**Lansing School District
Forest View Asphalt Replacement Bid Package 1**

Addendum 01

October 22, 2025

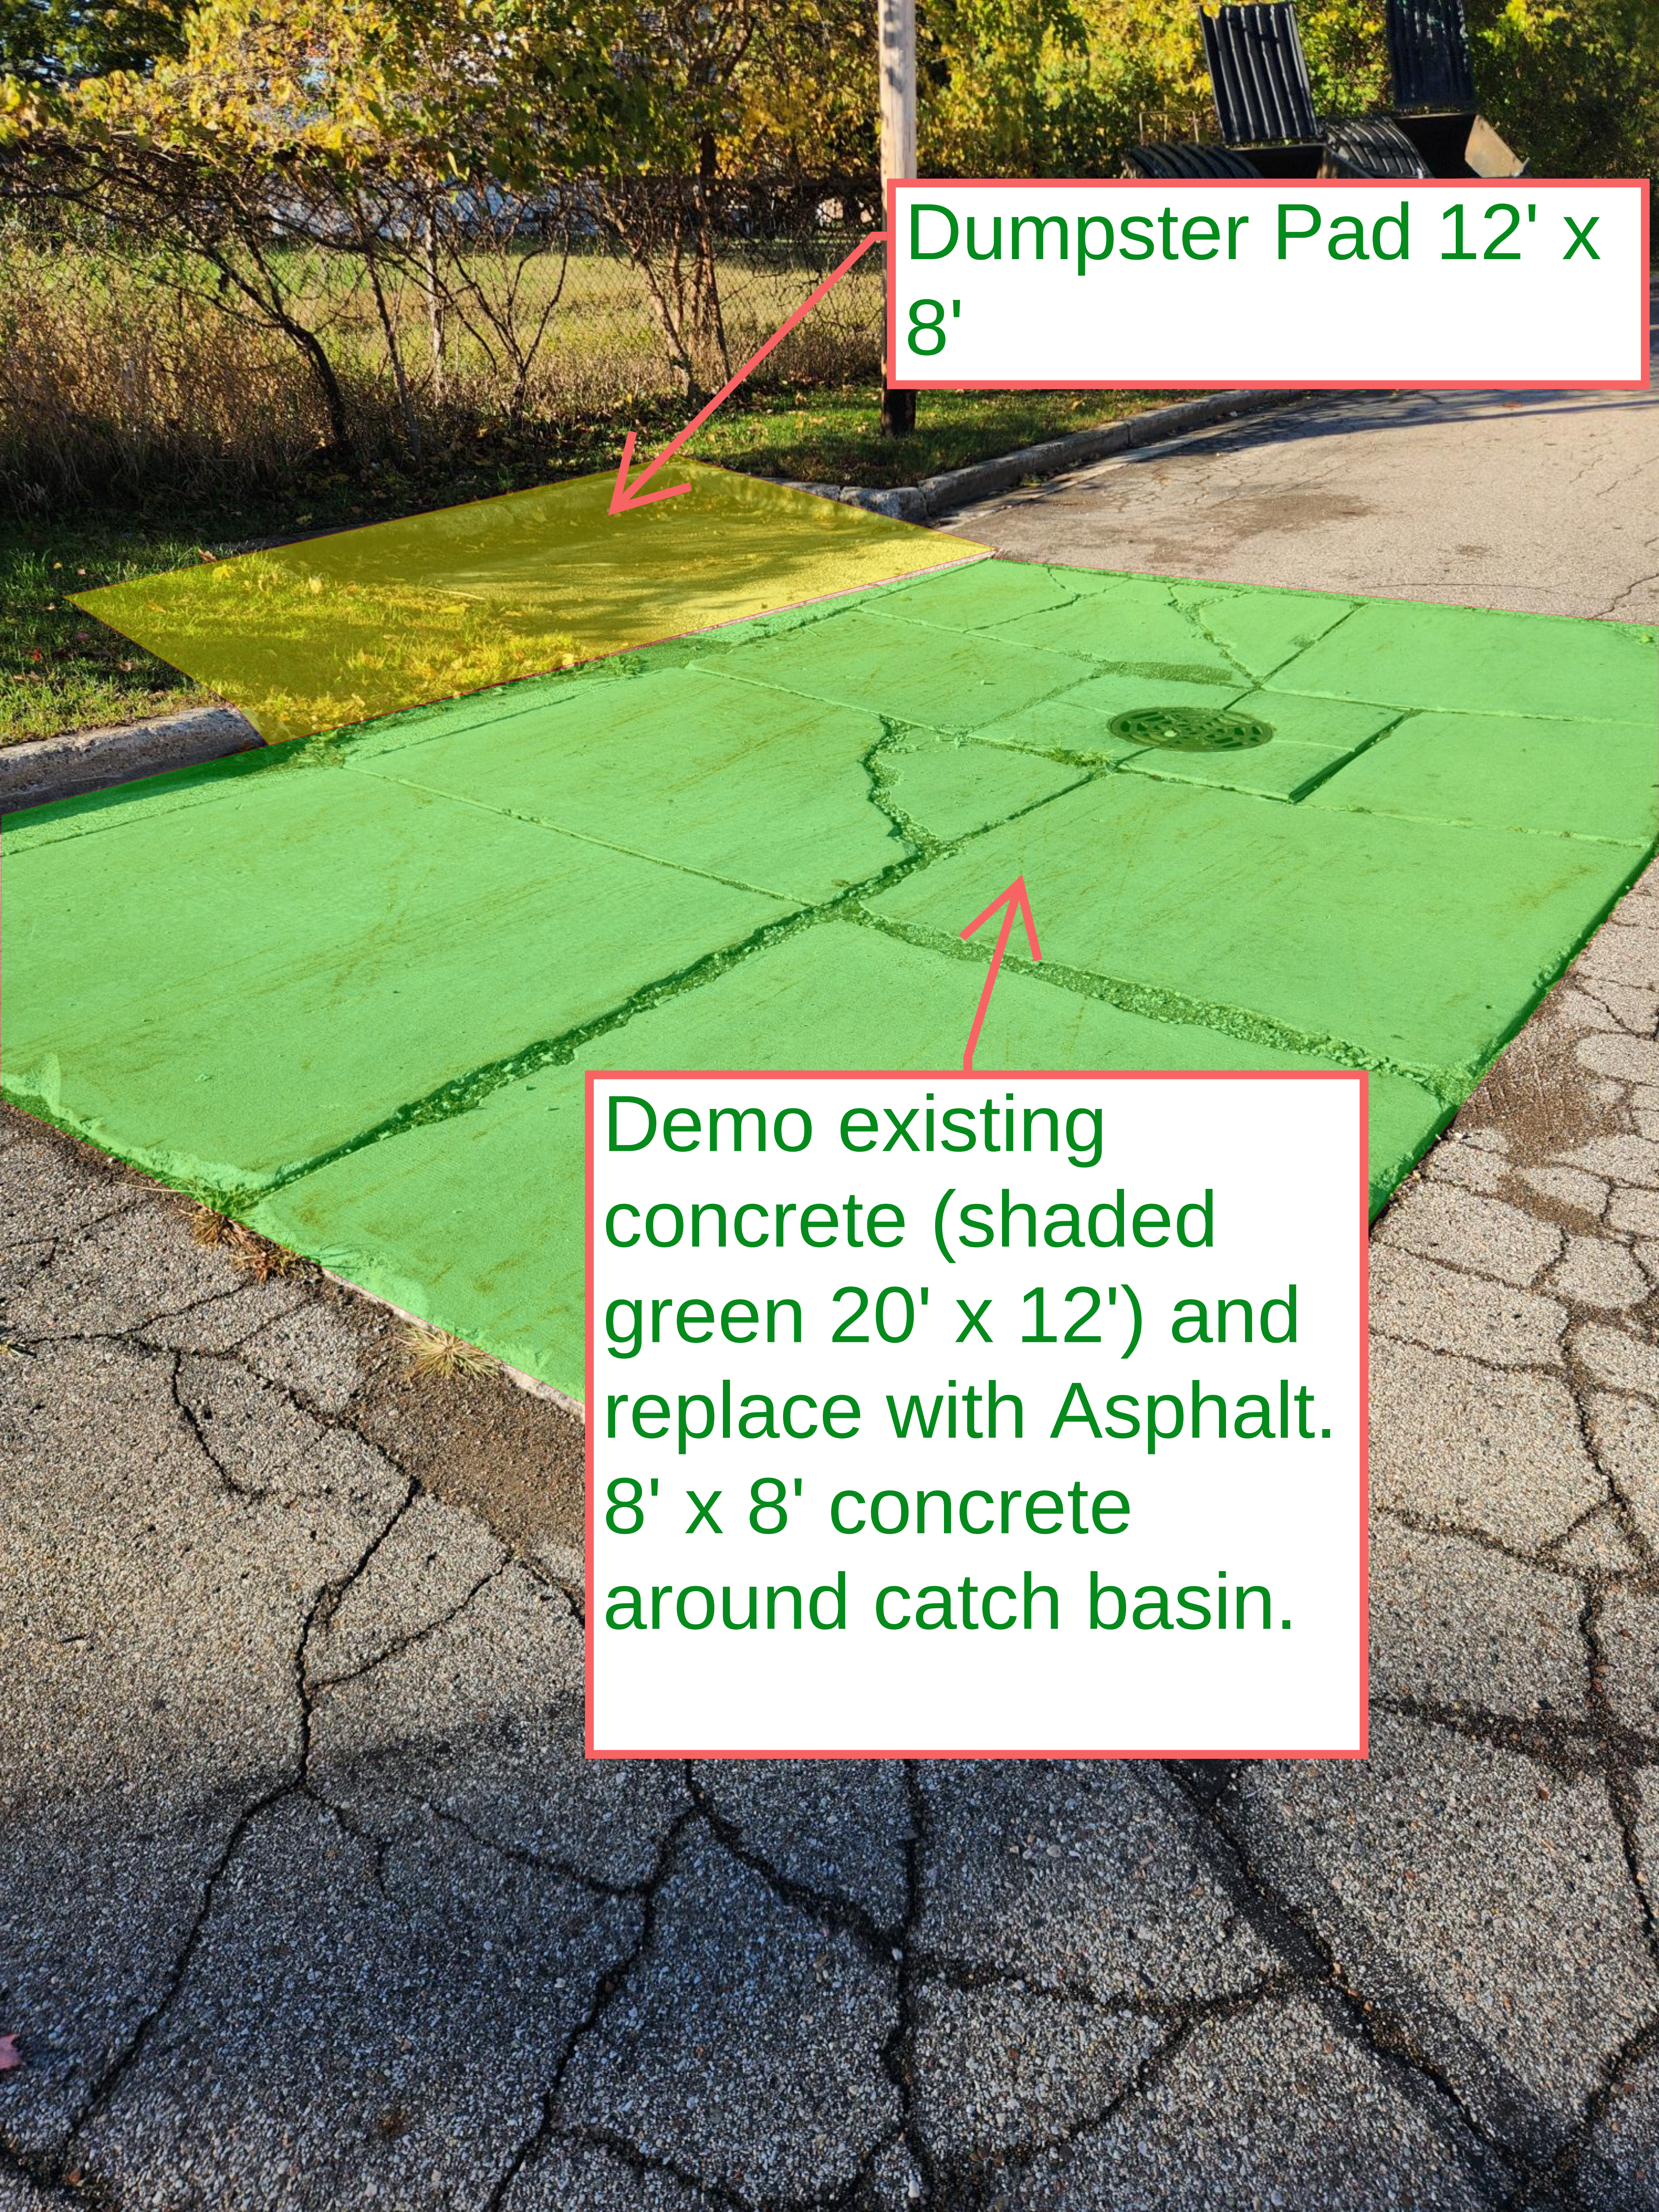
Dumpster Pad 12' x 8'

Demo existing concrete (shaded green 20' x 12') and replace with Asphalt. 8' x 8' concrete around catch basin.

New Concrete 8"
thick. 24' x 6'
